Columbus Subwatershed Study

Part II Plan Review

November 13, 2019 | Alternatives Review Memorandum

Prepared for:
City of Oshawa

Comparison of NHS Buffer Scenarios

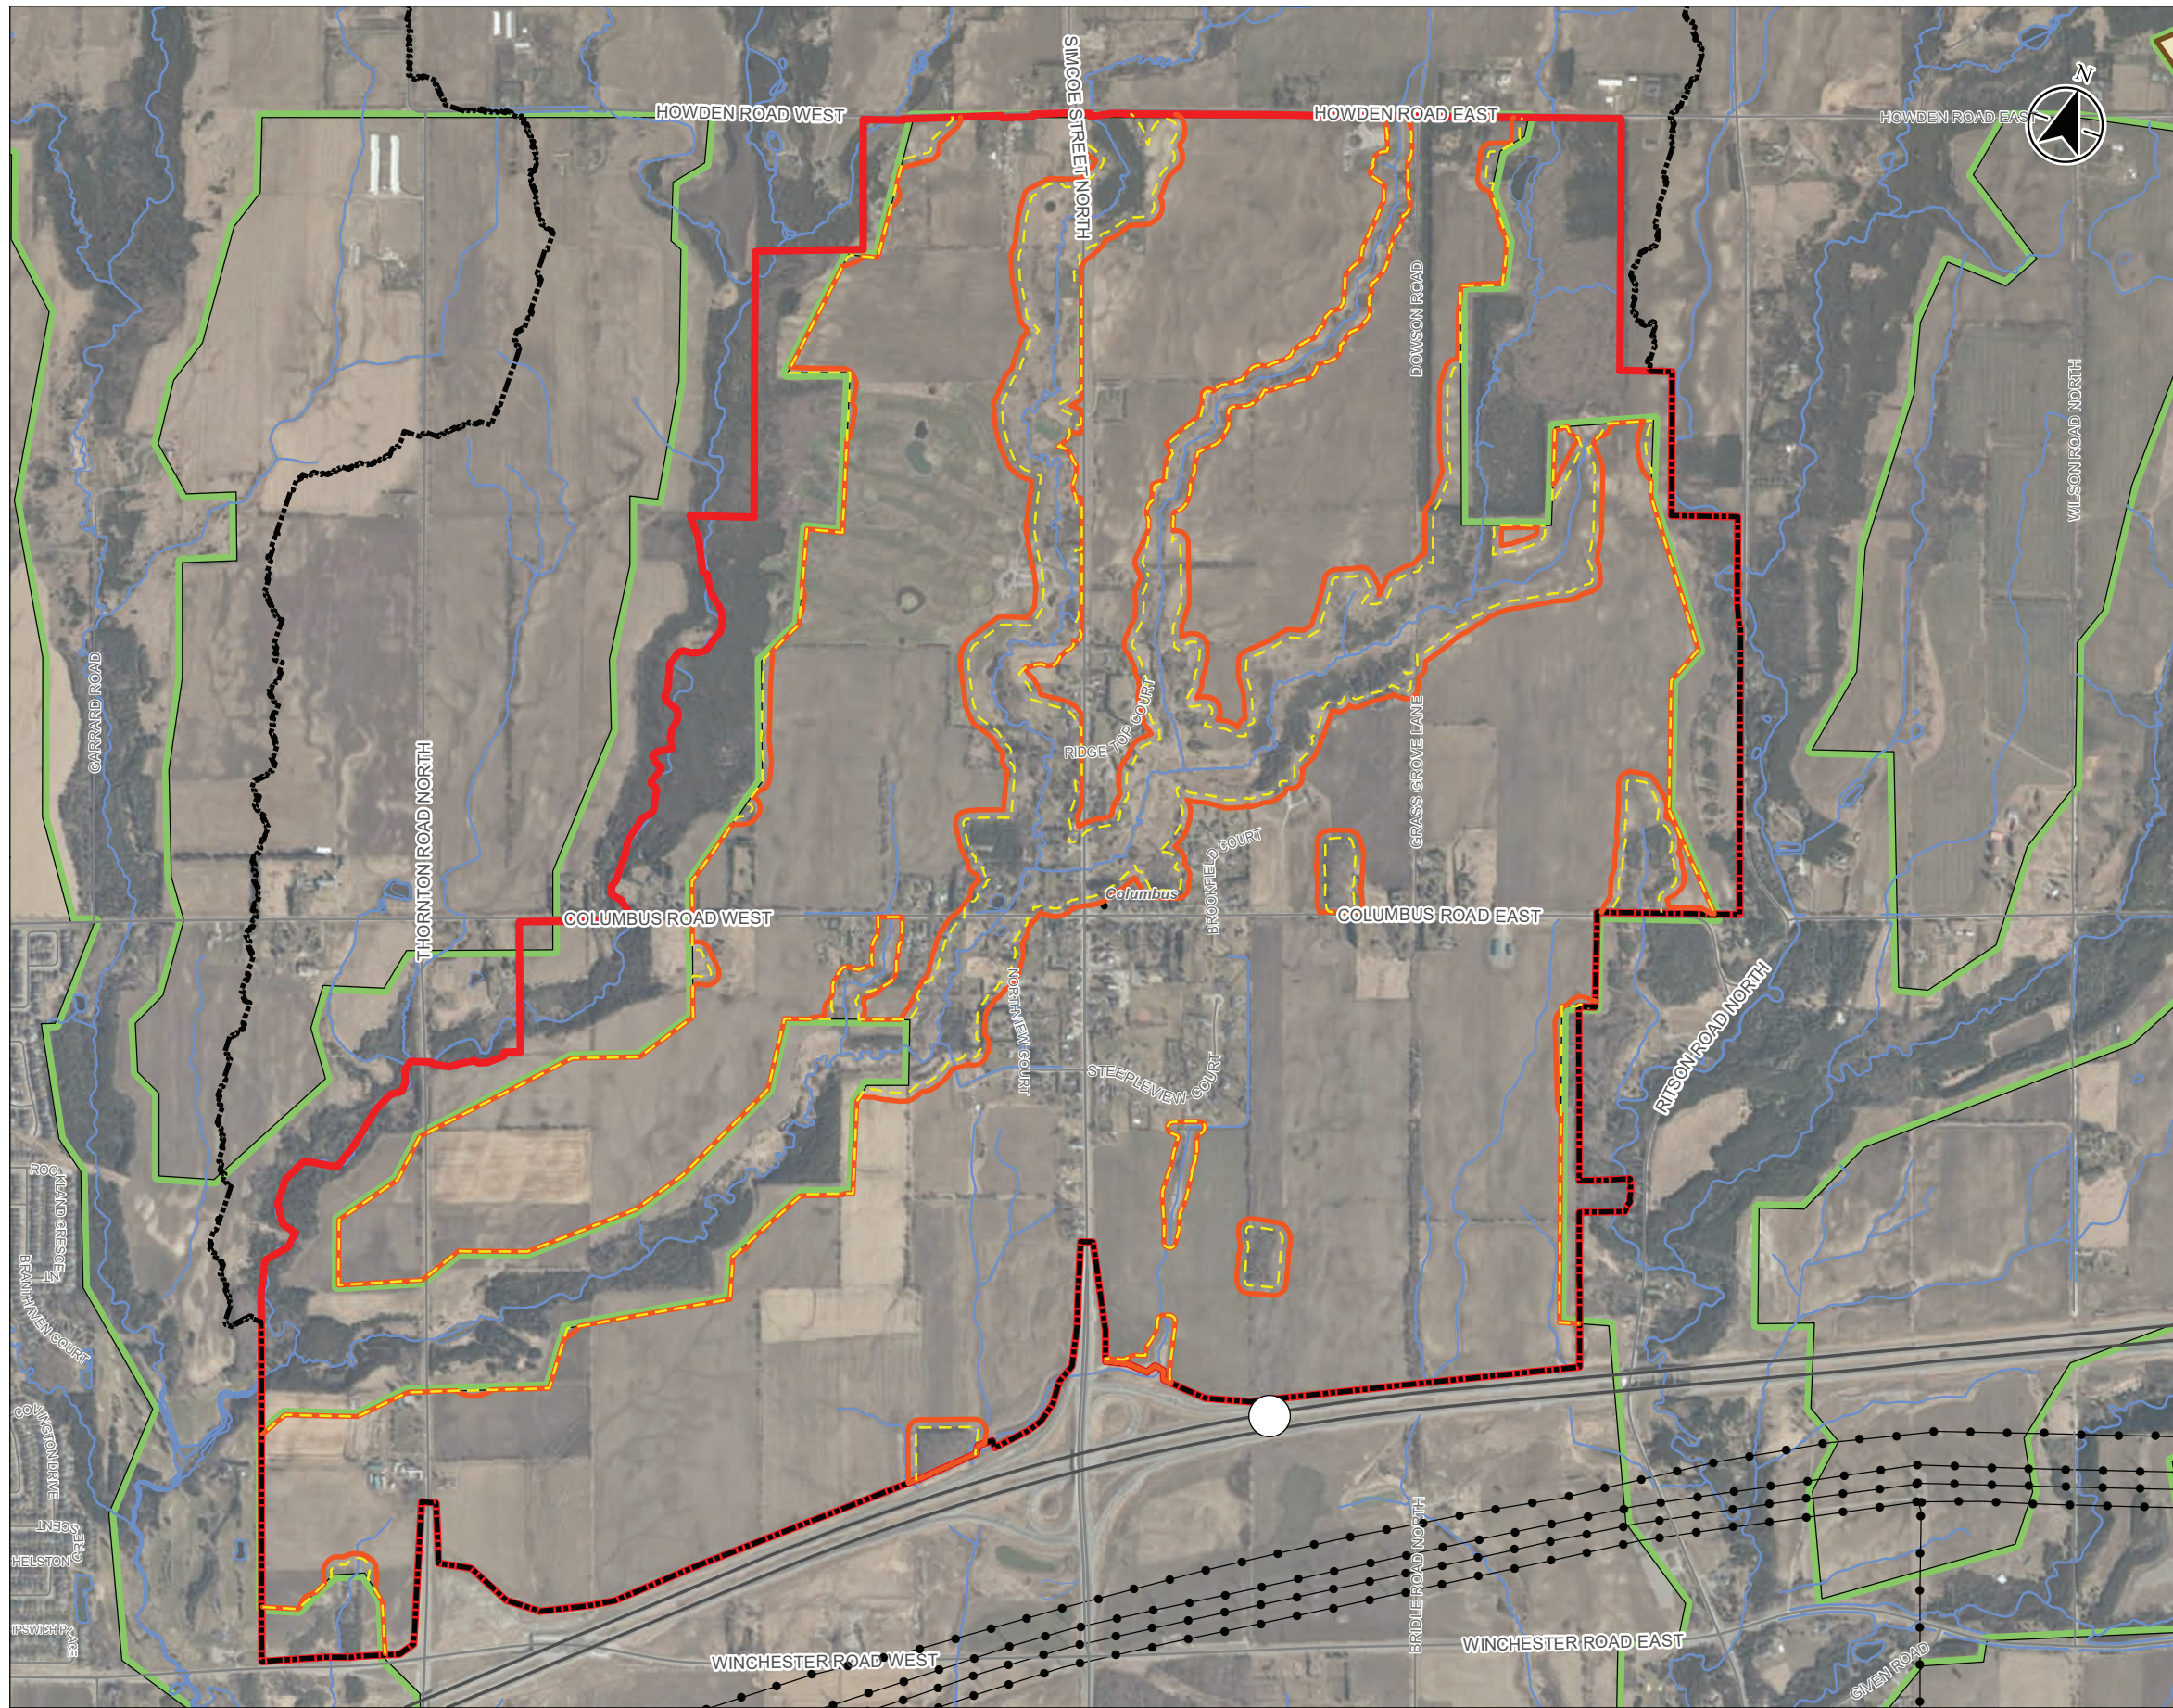
The analysis in **Table 3.4** indicates that the natural cover increases by 117.3 ha (12.8% of the Boundary Area) under scenario 1 and 88.4 ha (9.6% of the Boundary Area) in scenario 2. The watershed target for natural cover (30%) is exceeded under both scenarios (34.9% natural cover for scenario 1 and 31.7% for scenario 2).

Figure No.
6.1
Title
Proposed Subcatchment Mapping

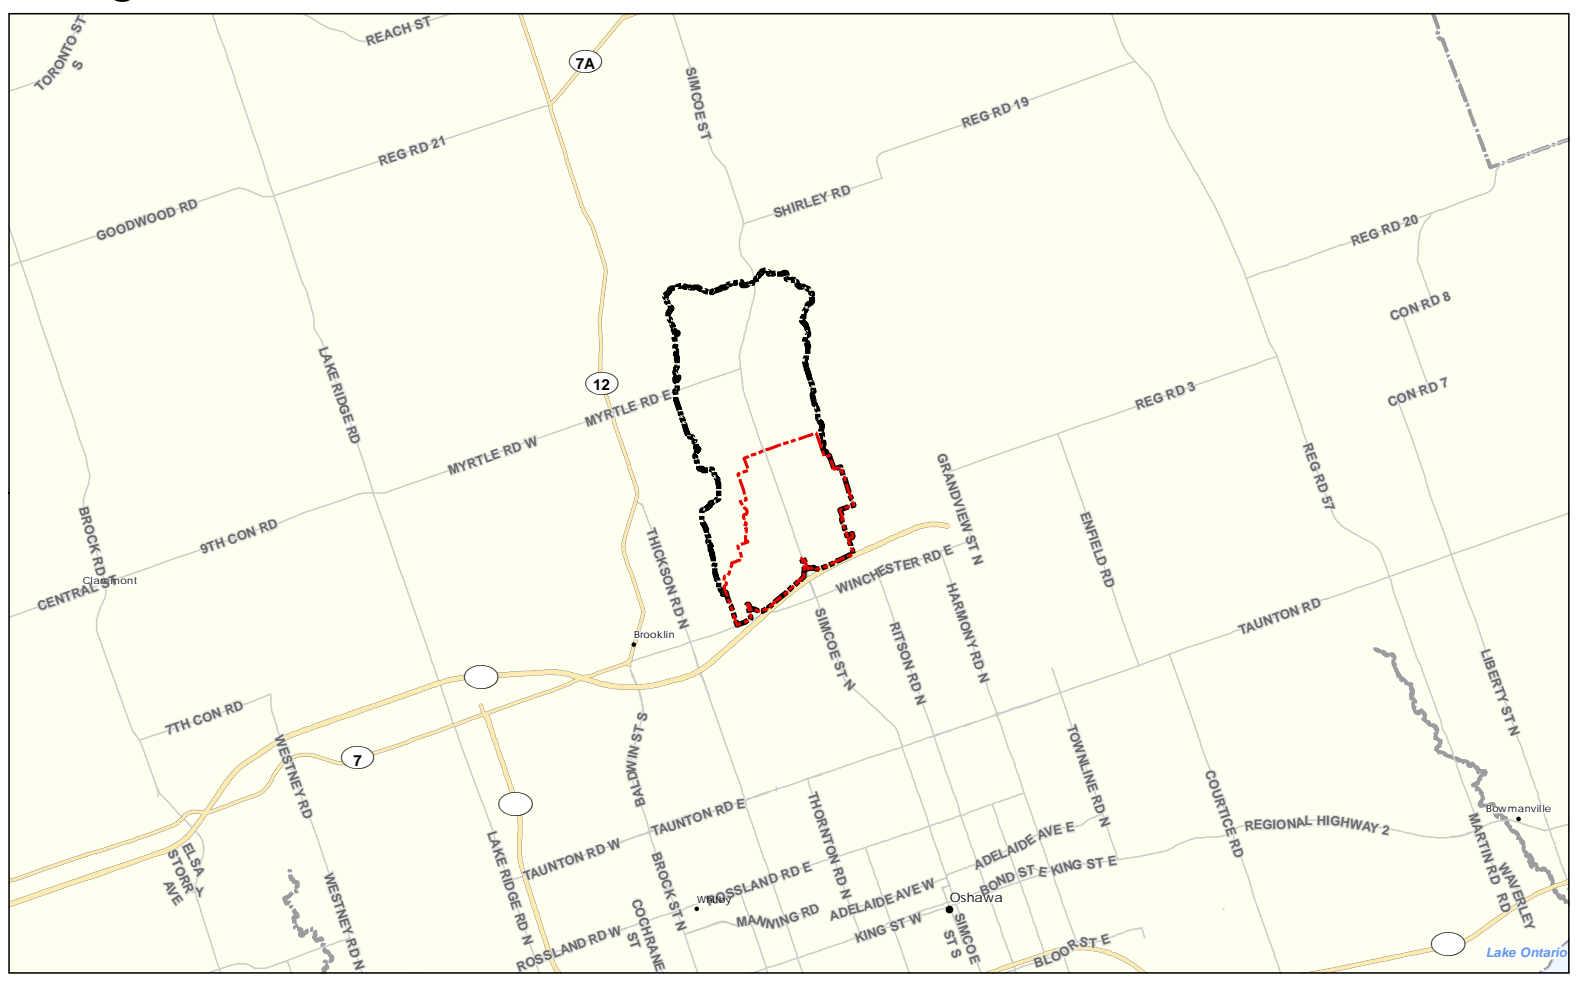
Figure 6.1 illustrates the existing and proposed subcatchment area delineations overlaid on the Alternative 2 land uses. It is noted that all underlying existing land uses within the identified Special Policy Area have been carried forward under the proposed land use conditions. The 'City Park Location Options' presented on Alternative 2 have been fully excluded from the

- Preliminary siting of conceptual S.W.M. pond locations have been provided on **Figure 6.1**. These locations are considered to be very flexible and will be subject to further refinement during the Phase 2 Report work program. It is fully expected that there will be opportunities to further refine the number of S.W.M. ponds, relocate S.W.M. ponds, combine S.W.M. ponds, etc. as part of the Columbus S.W.S. Phase 2 Report and future planning stages.
